# **ASEP**

## **-- Proposal for CVT --**

**GRB informal meeting #14**  
**28-29 January 2009**  
**JASIC**

**Gear : D-range , Annex3,i : D-range**

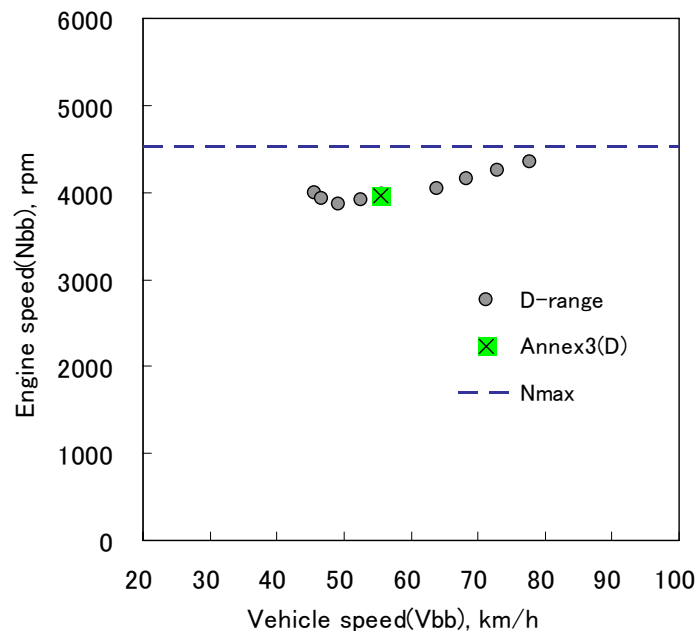
**OICA proposal compensate tyre noise only at the anchor point.  
There is the influence of tyre noise at every point as well as at the anchor point, because the relationship between vehicle speed and engine speed is not liner in case of CVT.**

# Revised OICA proposal for D-range test

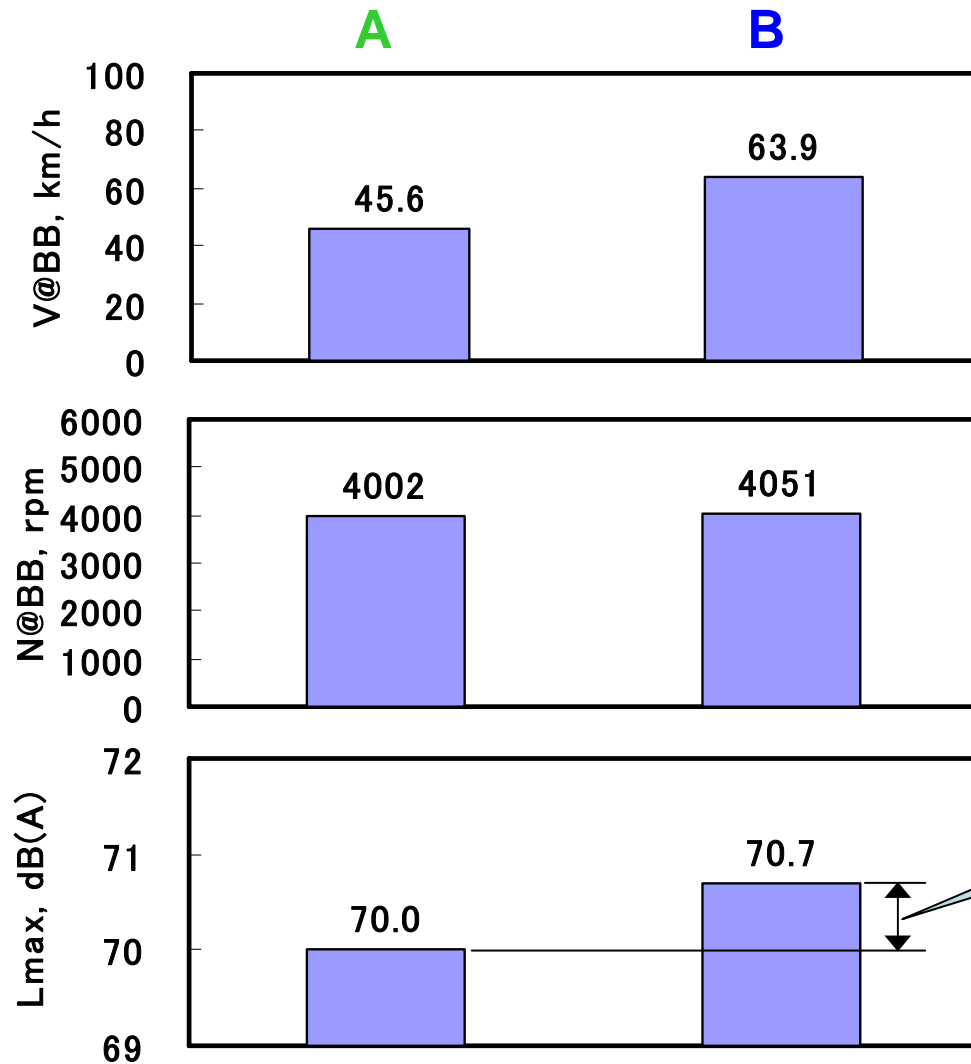
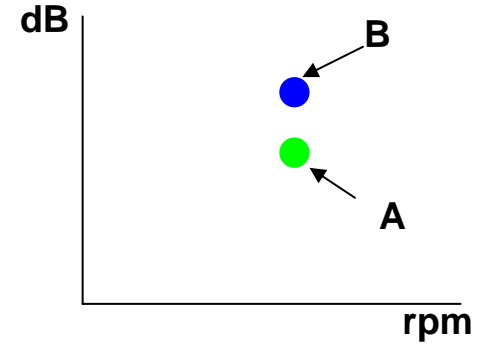
Same engine speed but different vehicle speed

0.7 dB

Influence of tyre noise

Should use maximum vehicle speed within ASEP test for the calculation of the anchor point

## 4.1. Determination of the anchor point for each gear ratio

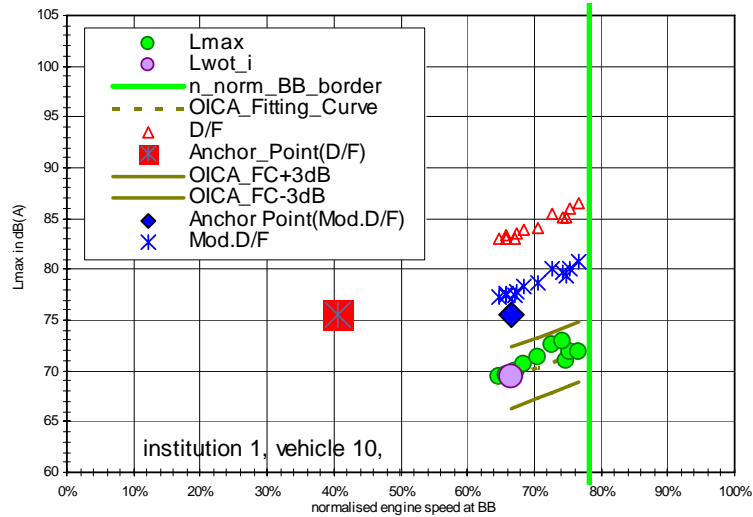
**In case of vehicles with CVT's non-locked gear ratios,  $\Delta v$  shall be used as follows;**

$$\Delta v = v_{\text{BBmax}} / v_{\text{BB,wotD,annex 3}}$$

**where  $v_{\text{BBmax}}$  = maximum vehicle speed during ASEP test**
